# VALIDATION OPINION FOR REVISION OF REGISTERED MONITORING PLAN

**Carbon Resource Management Limited**

**Hebei Shangyi Manjing East  
Windfarm Project**

**UNFCCC Reference Number: 0842**

#### Metering Diagram

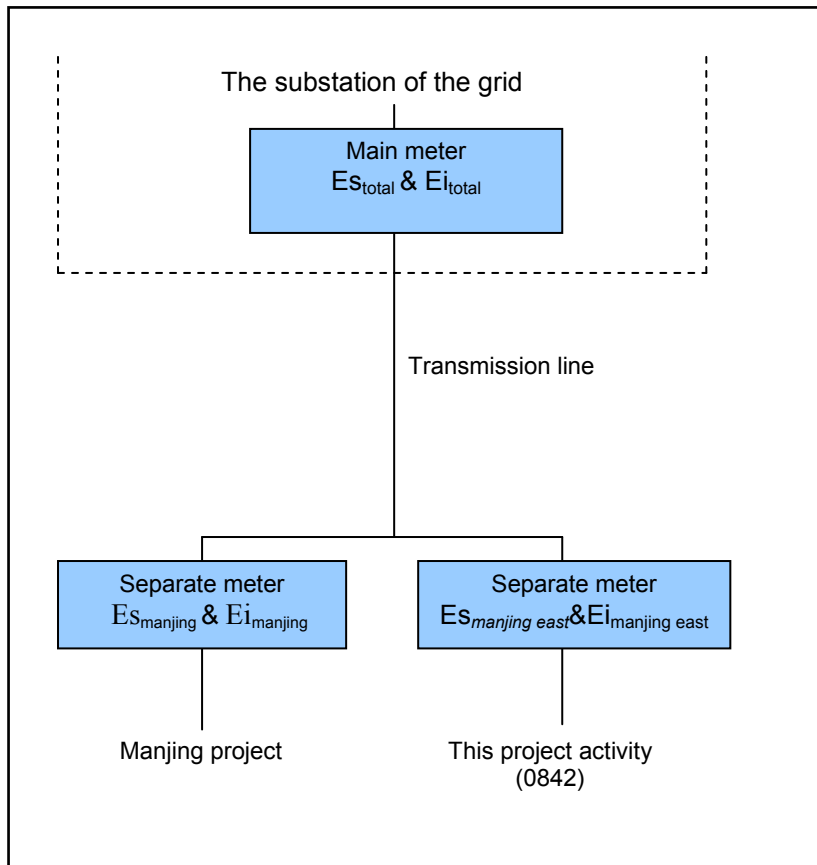
In the original Annex 4 of the registered PDD, it was mentioned that “*The net electricity generation will base on the main meter installed in Zhangbei substation*” (page 51, under Point 3. Installation of Meters), due to the meter installed in Zhangbei substation is the property of the grid company, and it is common that the grid company connects new power generation project (Manjing project) to the same transmission line used by the existing project, therefore the electricity measured by the main meter installed in Zhangbei substation actually consists of electricity supplied by other generation project, above description in the original Annex 4 of the registered PDD is not correct.

This revision is aiming to account for the fact that the project activity now shares the 110kV transmission line to the substation of the grid and the electricity meter installed there with other project as shown in the diagram below.

Onsite separate meter is used to monitor and calculate net generation (export minus import) from each generation project respectively, only the net electricity received by grid at its substation will be used to calculate the emissions reduction achieved by the project. This means that any transmission losses are accounted for and are shared between the projects on the basis of net electricity to the transmission line. The net electricity supplied from the project activity is calculated as follows:

$$EG_{\text{manjing east}} = EG_{\text{total}} * E_{\text{manjing east}} / [E_{\text{manjing east}} + E_{\text{manjing}}] - E_{\text{back-up}}$$

The revision monitoring plan (annex 4) provides a solution to calculate the net electricity delivered to the grid by registered CDM project and observes the monitoring methodology ACM0002 version 6. Monitored parameters have been interpolated in the revision of Section D (Application of a monitoring methodology and plan), i.e.  $EG_{\text{total}}$ ,  $E_{\text{manjing east}}$ ,  $E_{\text{manjing}}$  and  $E_{\text{back-up}}$ . It is also in line with the approach used in the first monitoring period which has been approved by EB during the first request for issuance.

This calculation method is considered appropriate; it efficiently allocates transmission losses which can be confirmed by the agreement between the project owner and the grid company. At the same time, the actual electricity generation and importation by individual project is also measured by onsite meters. This revision does not affect the emissions factor or calculation of the emission reductions achieved by concerned registered projects.
